## OICA PROPOSAL

### "04 SERIES OF AMENDMENTS TO ECE REGULATION No. 49"

(Emissions of C.I., NG and P.I. (LPG) engines)

Reference document: TRANS/WP29/752

ARRANGEMENTS OF APPROVAL MARKS  
(See paragraph 4.6. of this Regulation)

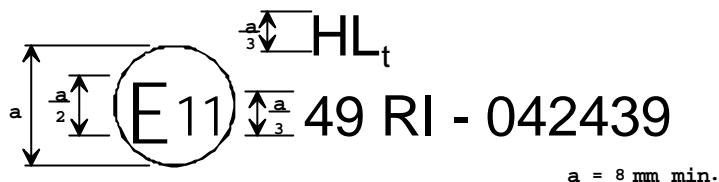
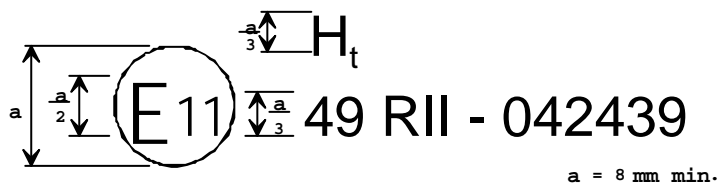
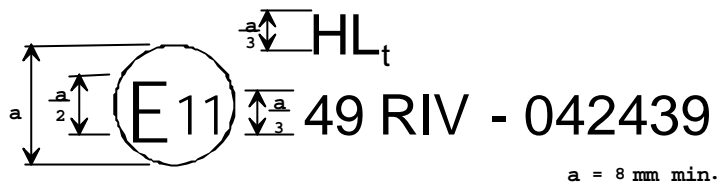
Amend the reference numbers to read:
